# **Department of Ecology Storage Building**

#### 1 - Administrative Review

## Design Review Staff Report Staff:

August 3, 2020

Existing Ponderosa Pine

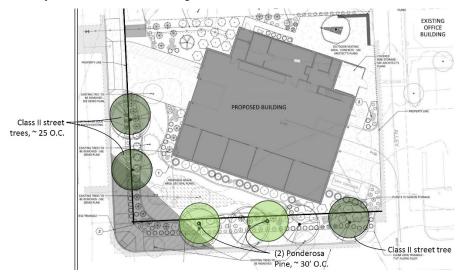
1. The applicant is strongly encouraged to retain one or both of the existing Ponderosa Pine trees that are slated for removal (near the intersection of Princeton and Madison, see image below). The Spokane City Council has adopted a resolution declaring the Ponderosa Pine the official tree of Spokane, and encourages the conservation of mature specimens located within the city.

Applicant's Response: The eastern-most tree must be removed as it is within the area of the building foundation. As a result, the other (westerly) pine may be compromised from the other tree's removal. It appears to be a one-sided tree having grown too close to the tree being removed and its health and safety for people and property are in question. And probably most important, this project has been mandated by the Governor to be a net-zero project, which relies significantly on the use of a roof-mounted photo-voltaic array that would be blocked from the sun by these threes. Their removal is imperative to this project's success.

Further Staff Comment: Based on conversations with the DRB Chair and Urban Forestry, staff recommends the following condition.

The applicant shall modify the street tree plant specification to match the image in the figure below. This is consistent with Urban Forestry's requirements for the Street variance, but the two westerly-most street trees along Princeton Avenue shall be Ponderosa Pine.
